寄件者: 陳灝然
寄件日期: 2025年08月03日星期日 22:59
收件者: tpbpd/PLAND
副本: Peter Pak Lun NGAN/PLAND
主旨: A/NE-LYT/841 補充資料
附件: 31064-R01-02.pdf
類別: Internet Email

Traffic Impact Assessment for Section 16 Planning Application A/NE-LYT/841 for Proposed Temporary Open Storage of Construction Materials and Machineries with Ancillary Facilities for a Period of 3 Years and Associated Filling of Land at Various Lots in D.D. 83, Lung Yeuk Tau, New Territories

TRAFFIC IMPACT ASSESSMENT REPORT

Reference: 31064-R01-02

Rev. :--

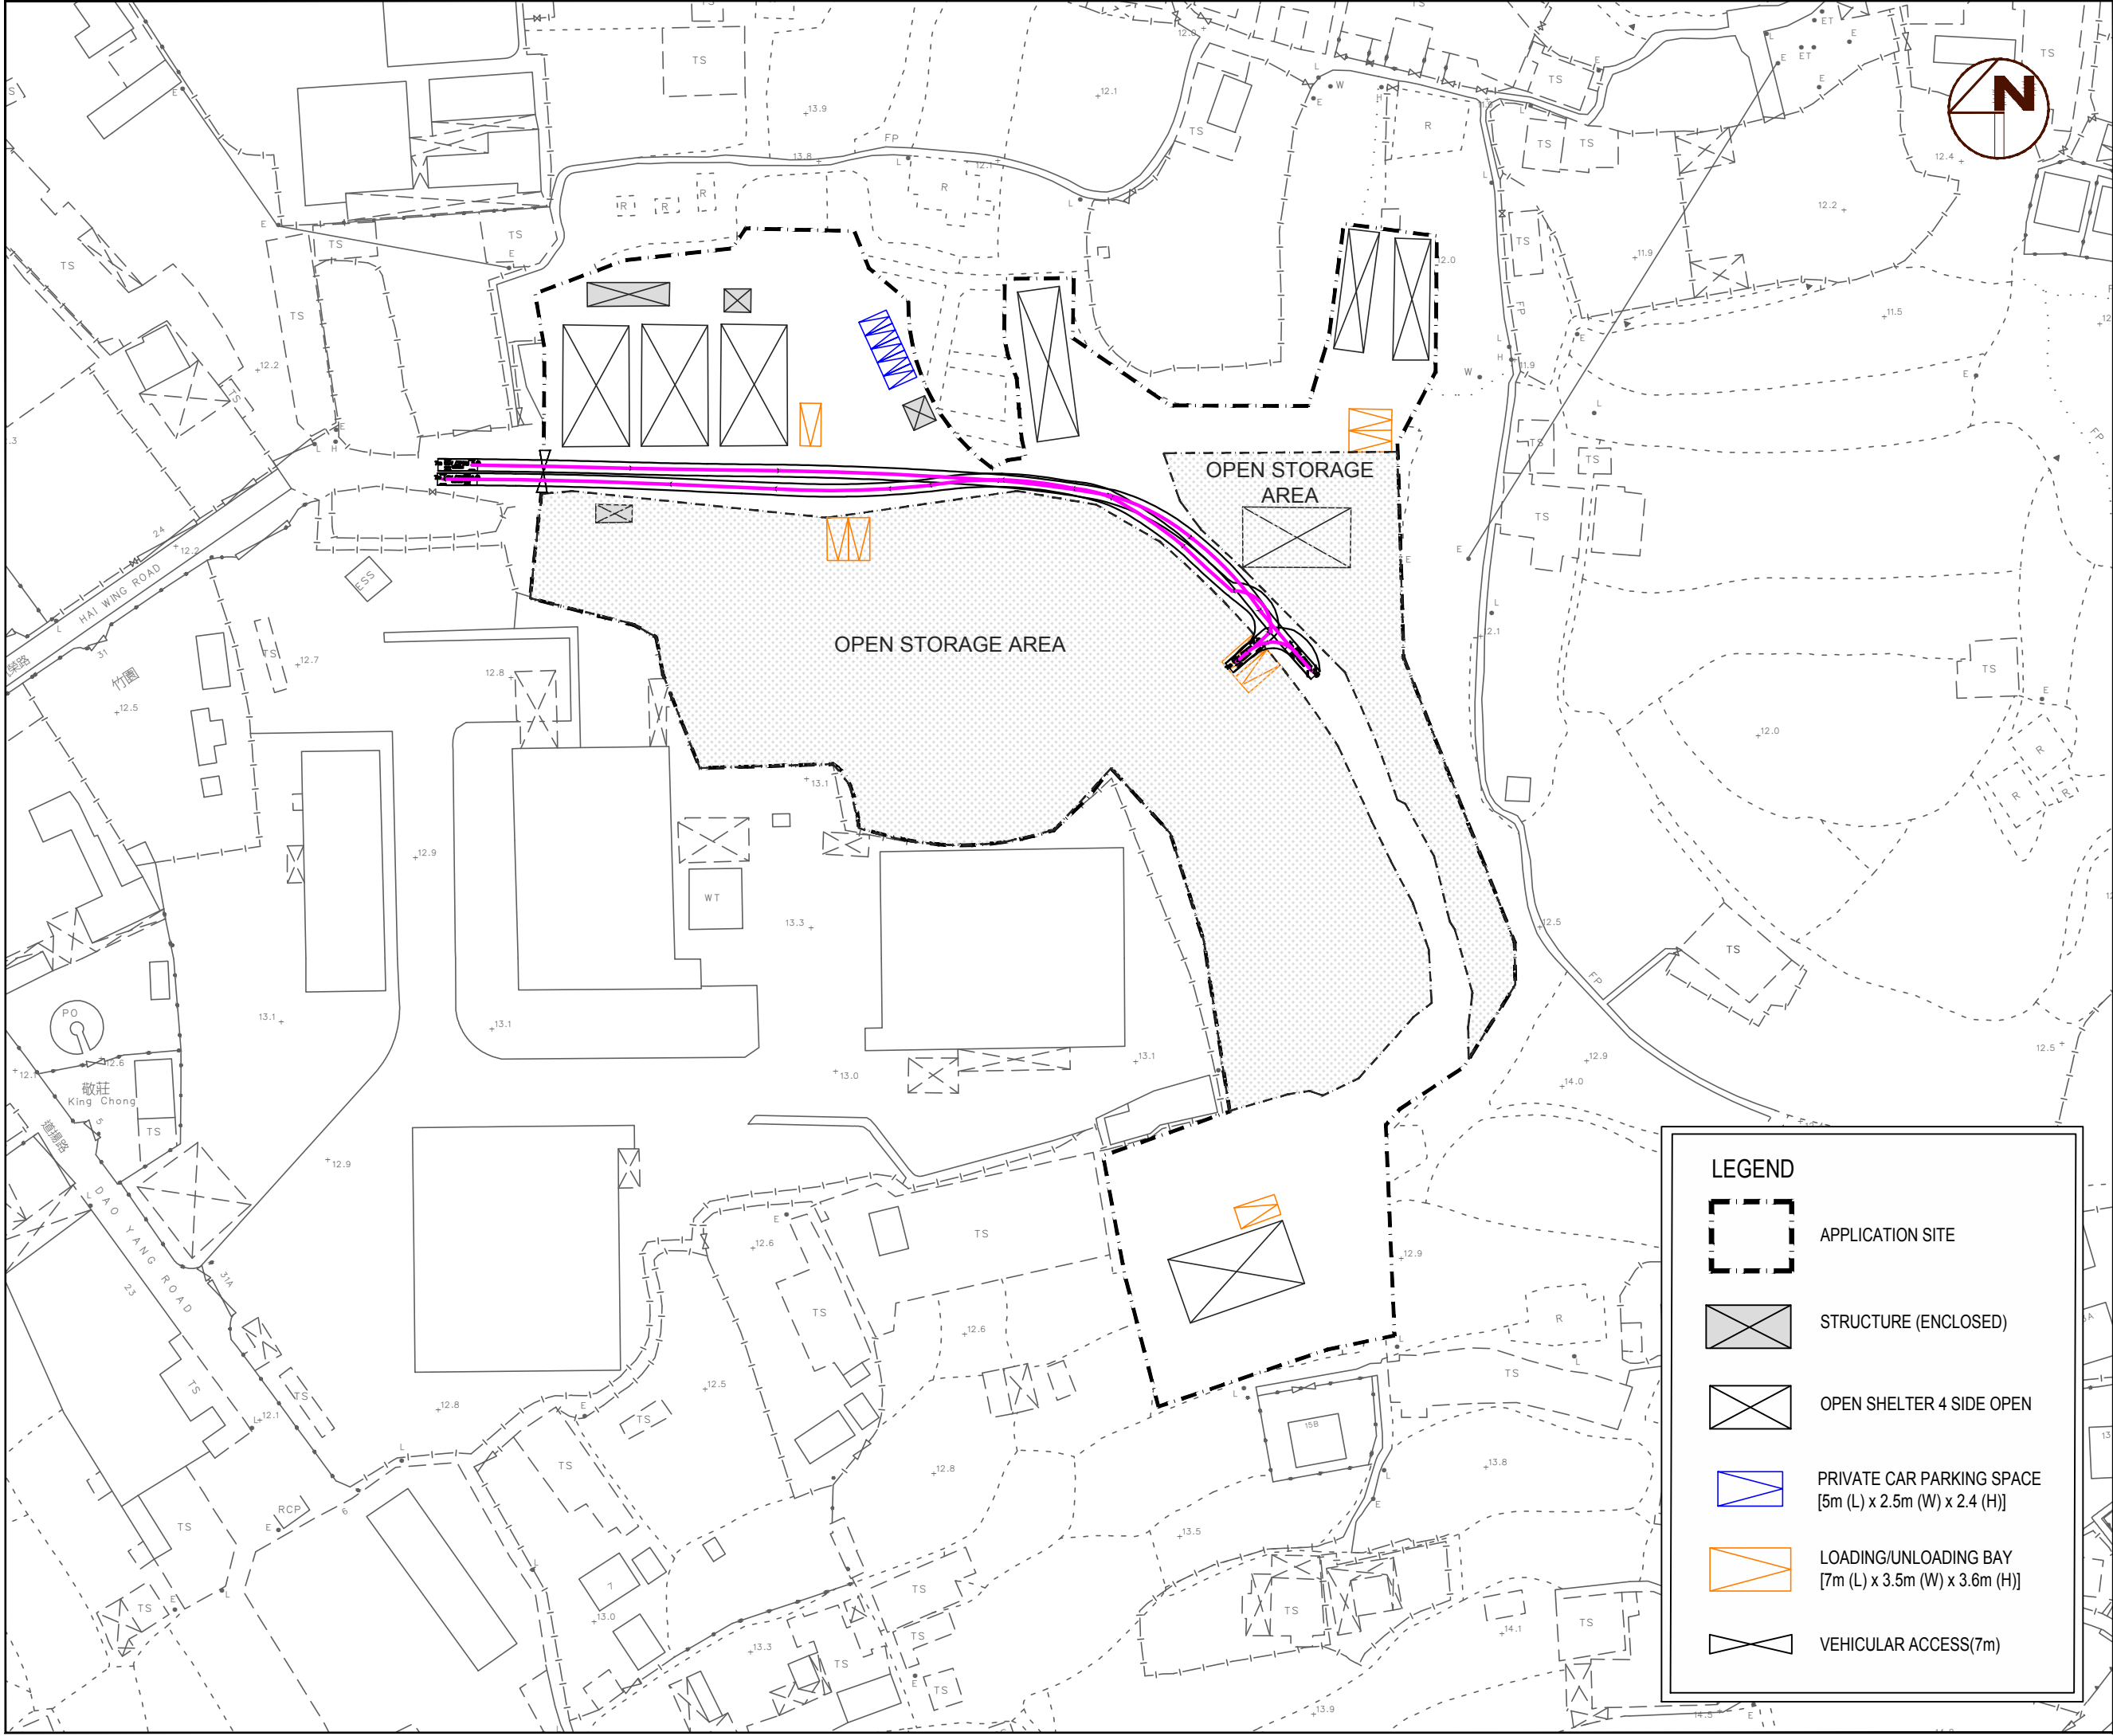
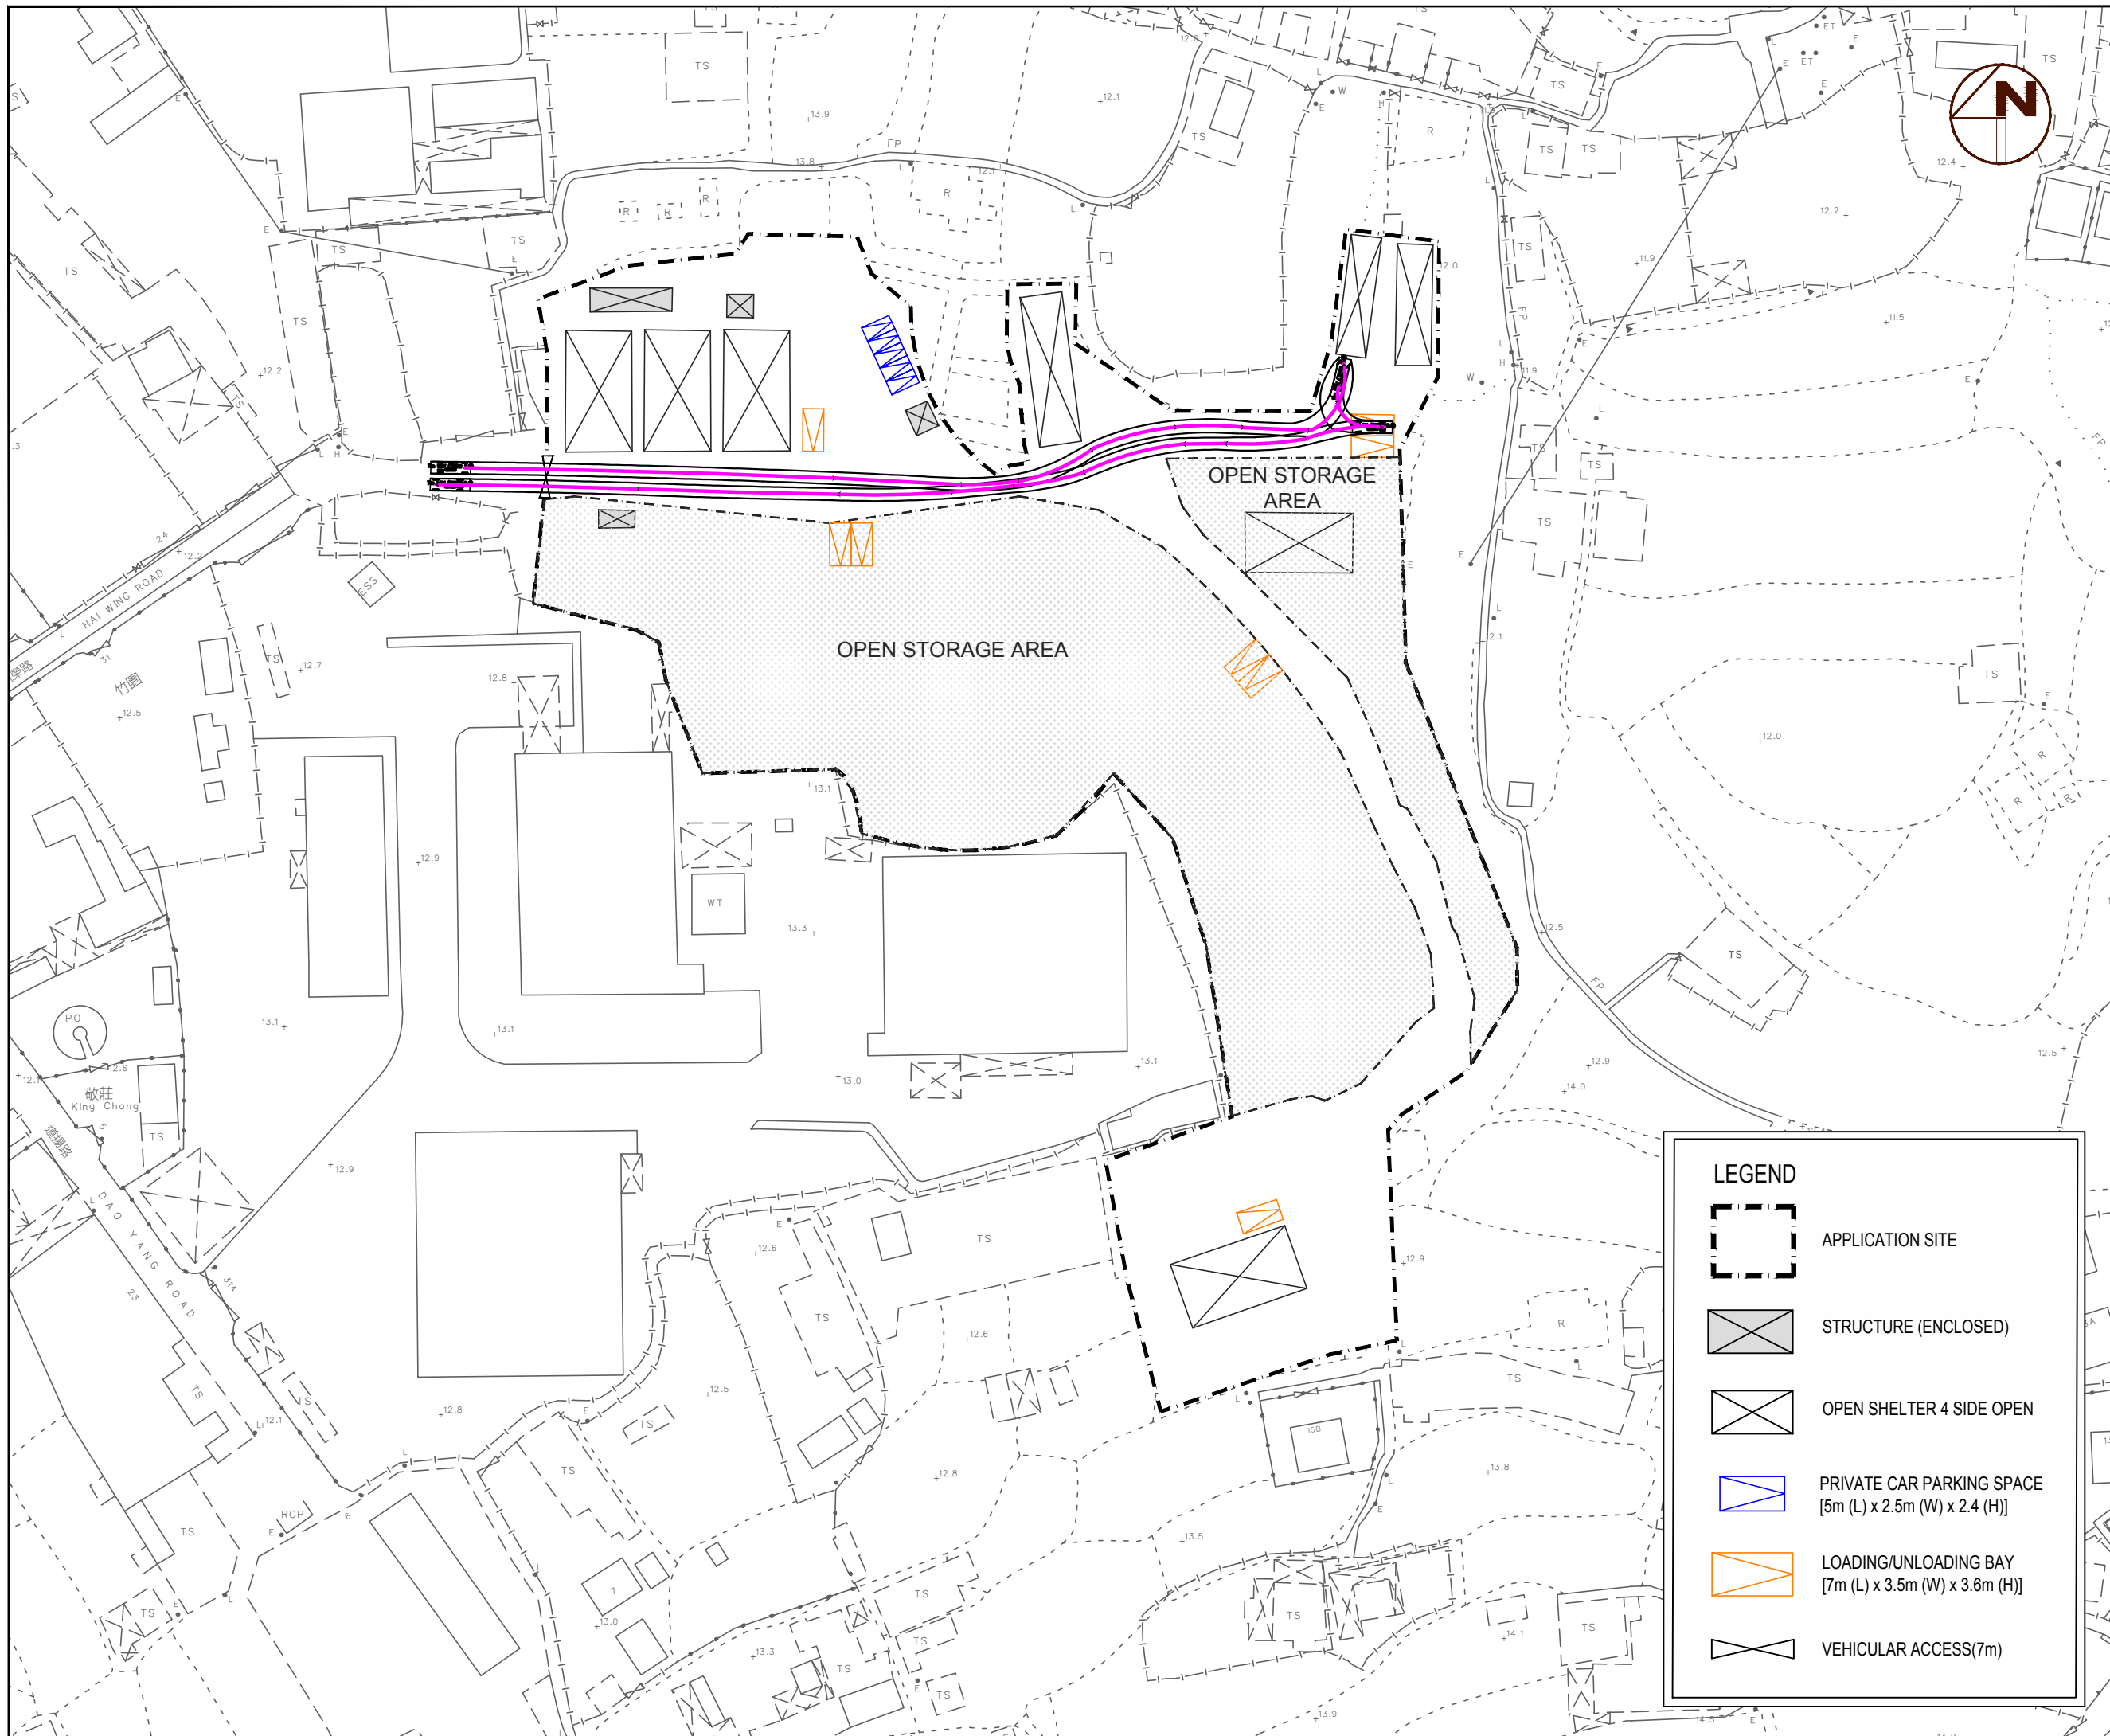
No	Transport Department's Comments	Responses
6	<p>(31.7.2025)</p> <p>Section 5.2: The applicant should advise the dimensions of vehicles used in swept path analysis and supplement the swept path diagrams for the maneuvering of vehicles from Sha Tau Kok Road – Lung Yeuk Tau into the Site as well as from the Site to Sha Tau Kok Road – Lung Yeuk Tau.</p>	<p>(1.8.2025)</p> <p>The swept path analysis has been conducted using a 7m long Light Goods Vehicle (LGV), which is the maximum size permitted for site access. Additional swept path diagrams showing maneuvering to/from Sha Tau Kok Road – Lung Yeuk Tau are provided in Appendix B (Figures SP-01 to SP-06).</p>
7	<p>(31.7.2025)</p> <p>Figures Nos. 3.3, 4.1 and 4.2: The applicant should provide the breakdown of vehicle flows (left-turning, straight ahead, right-turning and U-turning) from each arm of Junction B for reference.</p>	<p>(1.8.2025)</p> <p>The total inflow to the roundabout and the corresponding internal circulating flows were adopted for the capacity assessment. These flows have been reviewed, and the relevant figure has been updated accordingly. Should breakdown of turning movements be required, the applicant is prepared to provide supplementary analysis upon request.</p>
